INDIANA UTILITY REGULATORY COMMISSION

CAUSE NO. 45086

PUBLIC TESTIMONY OF

JOHN E. HASELDEN – PUBLIC’S EXHIBIT NO. 1

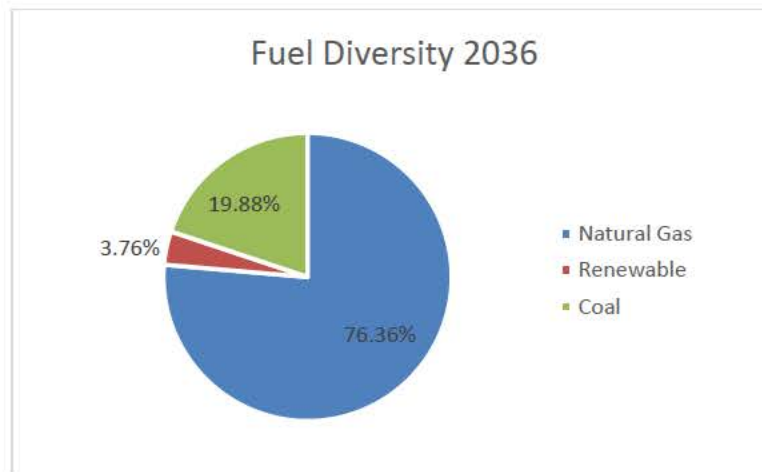
3 **Q: Vectren witness Mr. Wayne D. Games indicates on pages 15 and 16 of his**  
 4 **testimony, the Solar Project will aid in the diversification of its power supply.**  
 5 **Do you agree?**

6 A: No. The addition of the proposed Solar Project will have a de minimis effect on  
 7 Vectren's power supply diversification. Pie charts, provided on page 15 of Mr.  
 8 Games' direct testimony, show categories of available capacity, including energy  
 9 efficiency, in 2015 and forecasted for 2036; however, this does not represent the  
 10 diversification of the energy supplied. If units do not run or run sparingly, they do  
 11 not contribute to diversity of the power supplied. In response to OUCC DR 3.3<sup>6</sup>  
 12 requesting a similar breakdown of energy generated by source for the same time  
 13 periods (actual for 2015 and forecasted for 2036), the resulting charts look  
 14 differently:

1           There is obviously a large shift from coal to gas. However, the portion attributable to solar  
 2           in 2015 and forecasted in 2036 is extremely small -- approximately 1% of the total. The  
 3           remaining 2-3% of the renewable slice in 2036 is comprised of landfill gas and assumed  
 4           wind contracts. This is a true representation of the power diversity to be supplied, with the  
 5           exception that power supplied by the MISO market is omitted. It can certainly be argued  
 6           that Vectren's energy supply diversity will significantly change and become less diverse  
 7           with respect to renewable energy.
